Entergy Nuclear Operations, Inc.
Pilgrim Nuclear Power Station
600 Rocky Hill Road
Plymouth, MA 02360

SUBJECT: Response to Request for Additional Information for the Overall Integrated Plan in Response to the Commission Order Modifying Licenses with Regard to Requirements for Reliable Spent Fuel Pool Instrumentation

PNPS LETTER 2.13.057

**PILGRIM NUCLEAR POWER STATION
SPENT FUEL POOL INSTRUMENTATION ORDER
REQUEST FOR ADDITIONAL INFORMATION (RAI) RESPONSES**

FIGURE 1
 Pilgrim Nuclear Power Station Spent Fuel Pool Levels & References

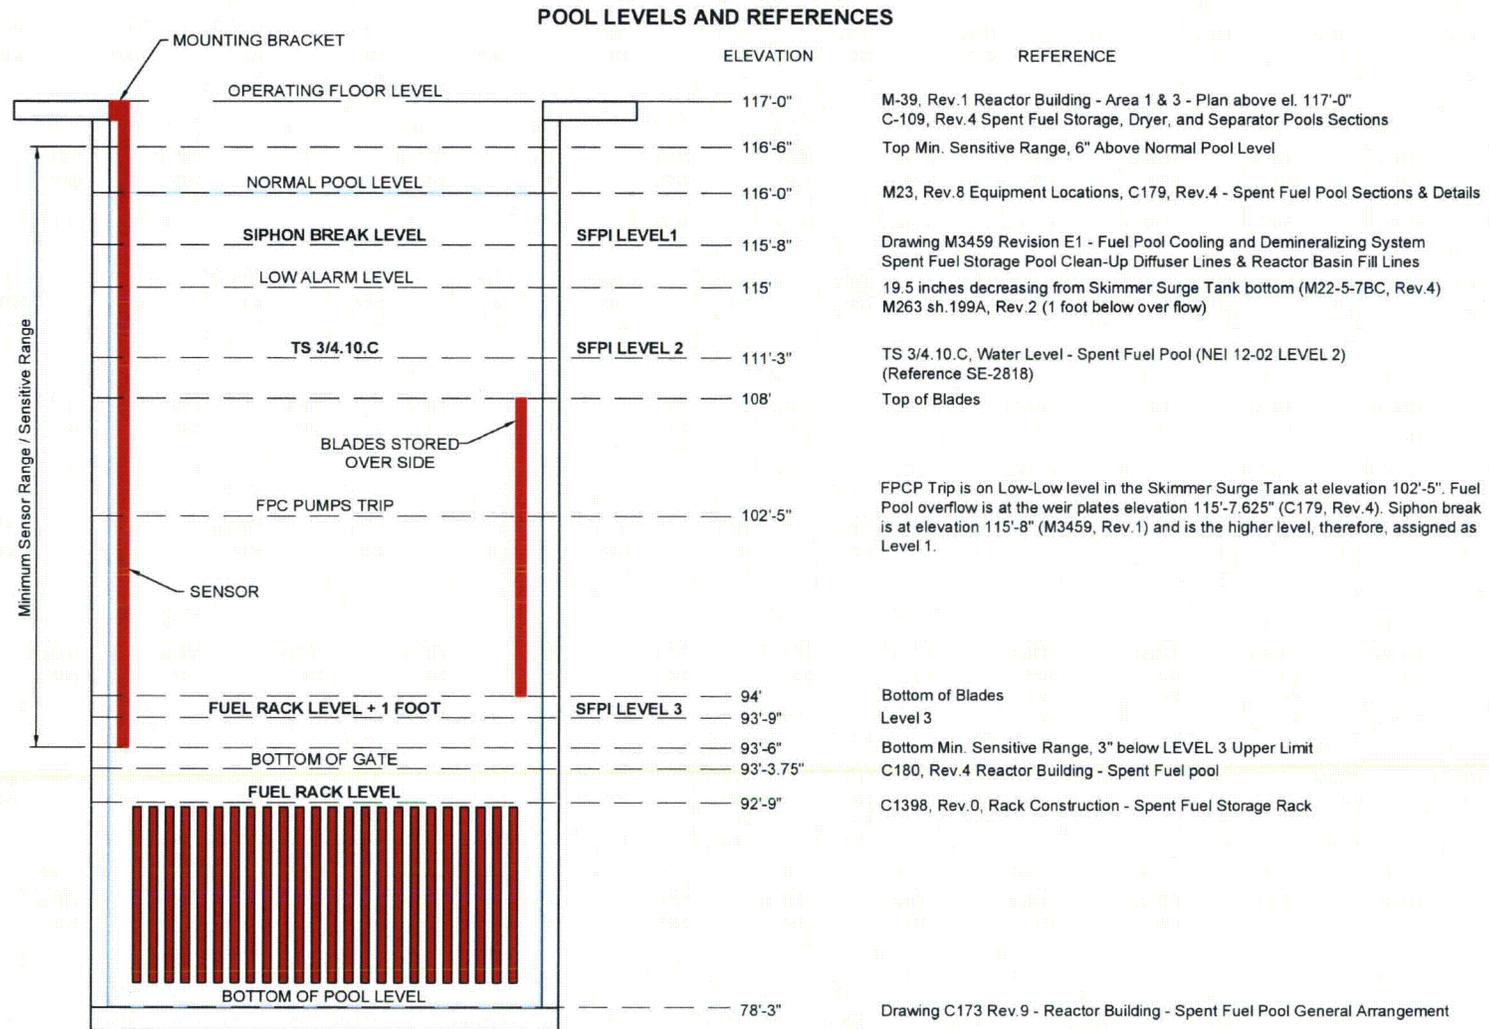
RAI-1.a) Please provide a clearly labeled sketch depicting the elevation view of the proposed typical mounting arrangement for the portions of instrument channel consisting of permanent measurement channel equipment (e.g., fixed level sensors and/or stilling wells, and mounting brackets). Indicate on this sketch the datum values representing Level 1, Level 2, and Level 3 as well as the top of the fuel. Indicate on this sketch the portion of the level sensor measurement range that is sensitive to measurement of the fuel pool level, with respect to the Level 1, Level 2, and Level 3 datum points.

RAI-1.b) The OIP states, "Other hardware stored in the SFP will be evaluated to ensure that it does not adversely interact with the SFP instrument probes during a seismic event." Given the potential for varied dose rates from other materials stored in the SFP, describe how level 2 will be adjusted to other than the elevation provided in section 2 above.

The requested information is provided in Figure 1. The figure indicates Levels 1, 2, and 3 as well as the approximate location of the proposed mounting bracket incorporating the Seismic Category I attachment. The sensor is a perforated tubular coaxial waveguide that provides continuous level measurement axially and is sensitive over its entire length. This sketch applies to both the primary and backup channels.

The spent fuel pool (SFP) level lower instrument span or probe bottom extends down to at least three inches below the upper limit of the range of Level 3 to account for channel accuracy or instrument loop uncertainty. Therefore, the SFP level probe bottom/span extends down to at least elevation 93 feet 6 inches (see Figure 1). The SFP level upper instrument span, at a minimum, includes normal water level high alarm. Note that Level 3 is shown in accordance with Nuclear Energy Institute (NEI) 12-02 Revision 1 guidance relative to the top of the rack; the top of the fuel is not shown.

Level 2 has been adjusted to account for materials stored in the SFP by specifying Level 2 at the Technical Specification minimum limit (refer to Figure 1).

FIGURE 2

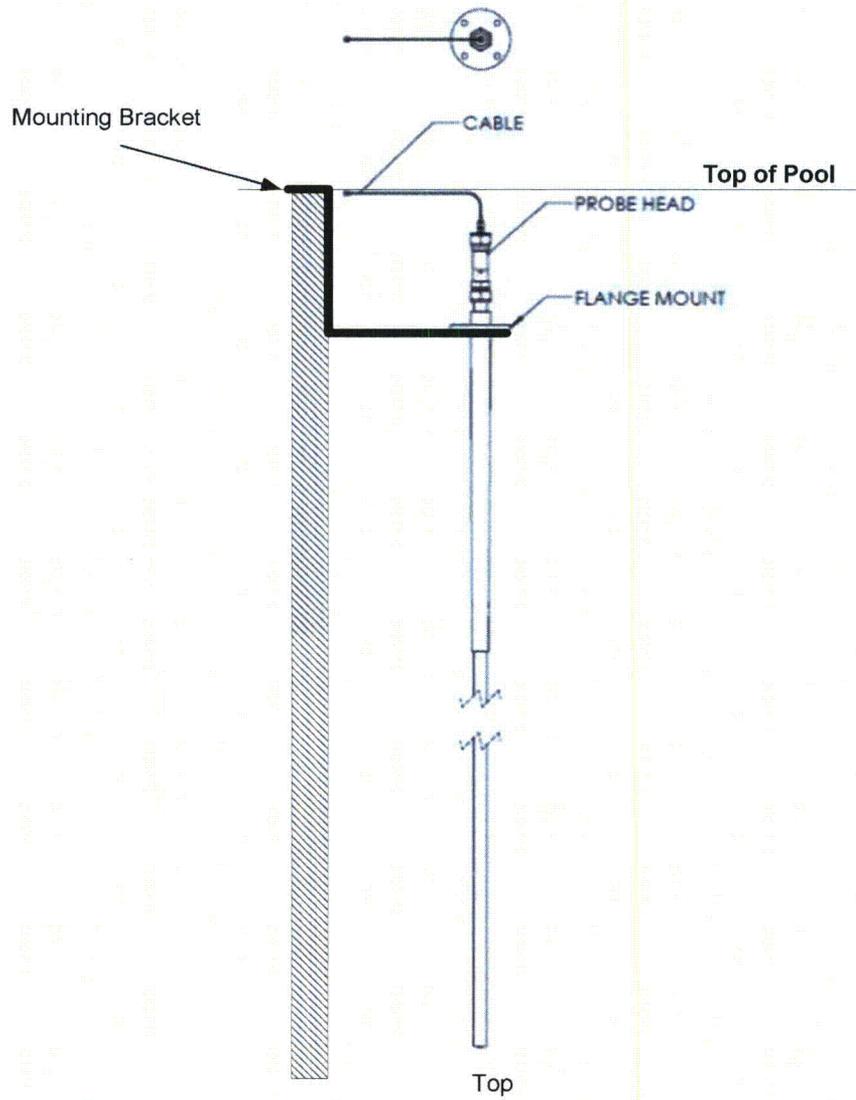
RAI-2.b) Please provide a description of the manner in which the level sensor (and stilling well, if appropriate) will be attached to the refueling floor and/or other support structures for each planned point of attachment of the probe assembly. Indicate in a drawing the portions of the level sensor that will serve as points of attachment for mechanical/mounting or electrical connections.

The proximal portion of the level probe is designed to be attached near its upper end (refer to Figure 2) to a Seismic Category I mounting bracket configured to suit the requirements of a particular SFP. The bracket may be bolted and/or welded to the SFP deck and/or SFP liner/wall according to the requirements of the particular installation per Seismic Category I requirements..
